To: Kristopher Byrd, Well Construction Section Manager
From: Tommy Laird, Well Construction Program Coordinator
Subject: Review of Water Right Application G-19032
Date: February 2, 2024

Groundwater Application Review Summary Form

Application # G- 19032

TO: Water Rights Section Date 12 August 2021
 FROM: Groundwater Section Gerald H. Grondin
 Reviewer's Name
 SUBJECT: Application G- 19032 Supersedes review of _____
 Date of Review(s) _____

Water-Level Measurements in Nearby Wells

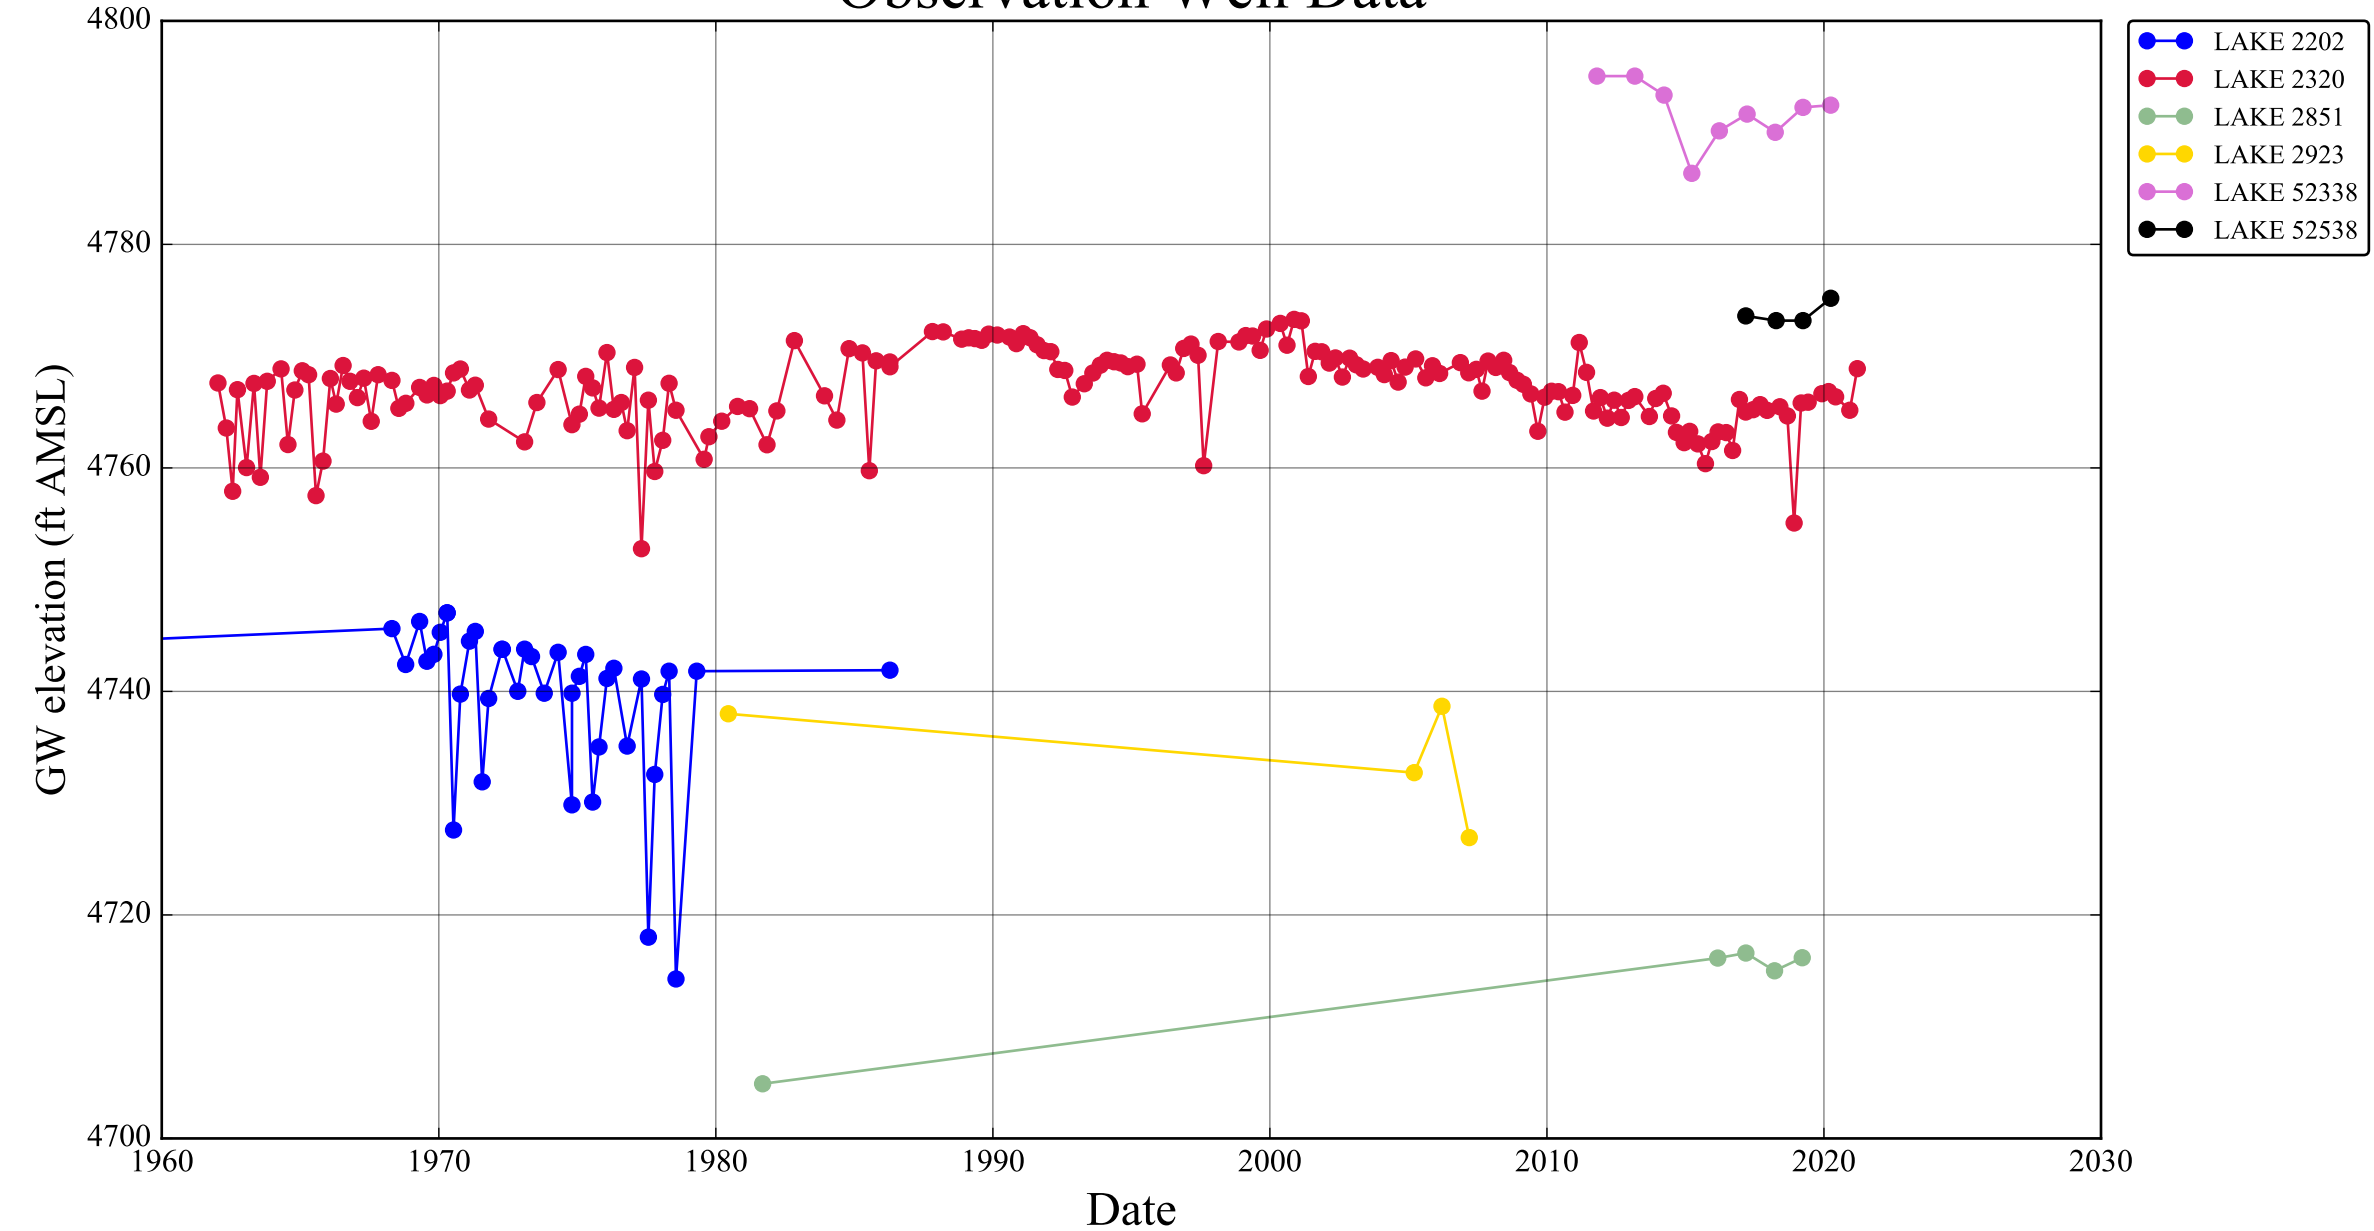
The attached hydrograph shows available groundwater level data related to wells located north and east of Goose Lake. The data shows variability over the decades but no discernable long term trend yet.

Proposed Well 3 to Cogswell Creek

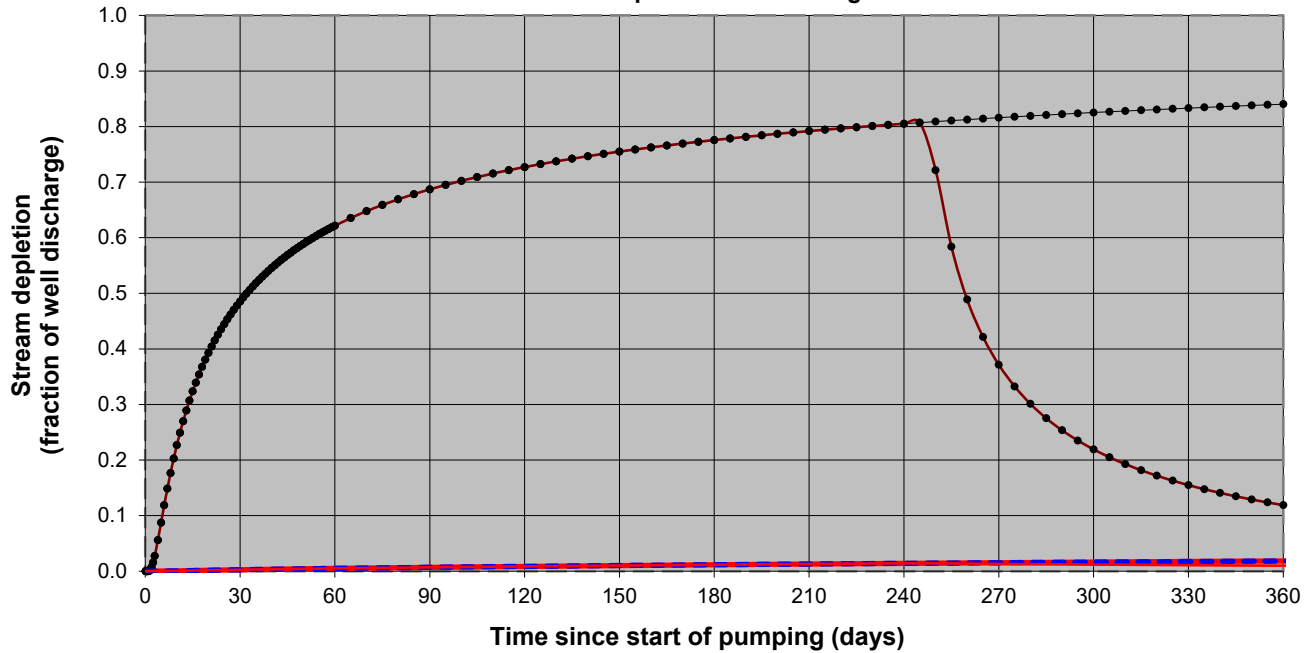
Hunt (1999) was used to calculate groundwater interference with Cogswell Creek using the values noted above for the Theis calculations as well as a stream width of 5 feet, streambed thickness of 25 feet, and a streambed hydraulic conductivity of 0.02 feet/day. By the end of the irrigation season, interference with the creek was calculated as 1.4 percent of the pumping rate. The calculated interference exceeded one percent the natural creek flow 9 of 12 months with a maximum interference of 7.68 percent during the lowest creek flow month.

Proposed Well 3 to Thomas Creek

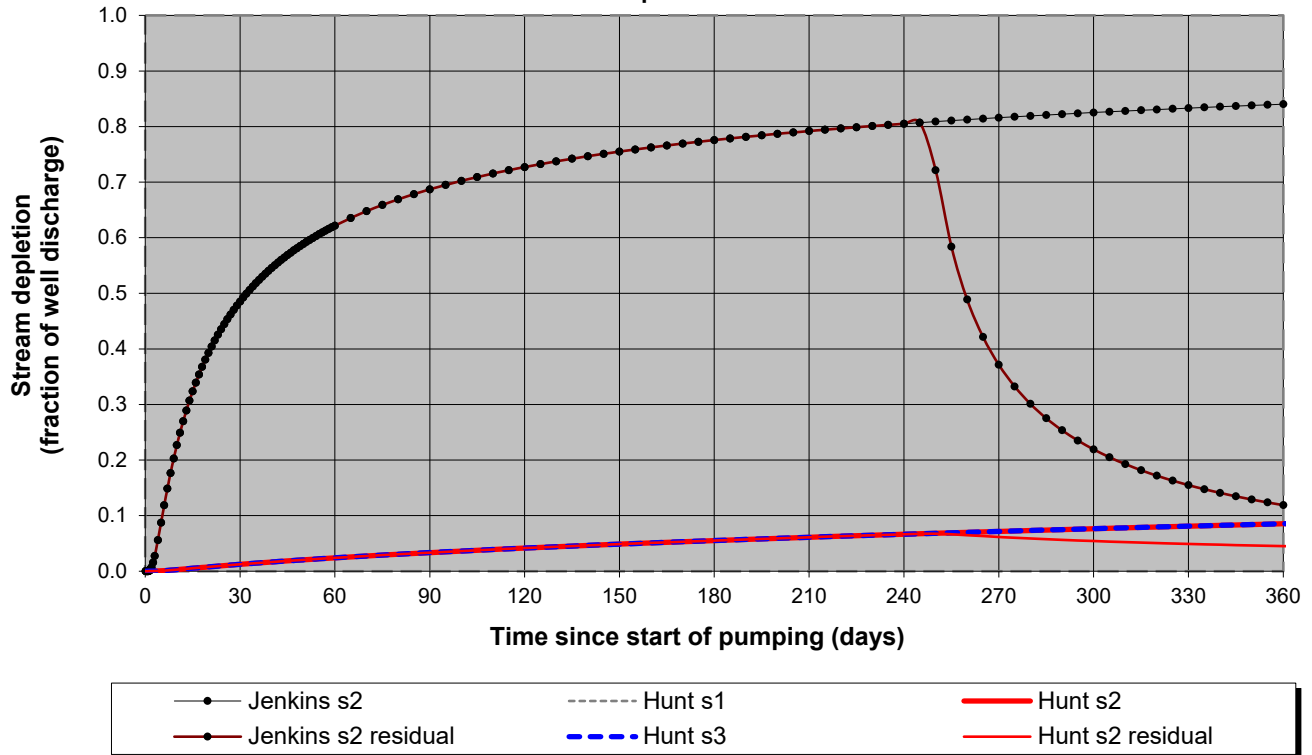
Hunt (1999) was used to calculate groundwater interference with Thomas Creek using the values noted above for the Theis calculations as well as a stream width of 25 feet, streambed thickness of 25 feet, and a streambed hydraulic conductivity of 0.02 feet/day. By the end of the irrigation season, interference with the creek was calculated as 6.7 percent of the pumping rate. The calculated interference exceeded one percent the natural creek flow 7 of 12 months with a maximum interference of 4.04 percent during the second lowest creek flow month.
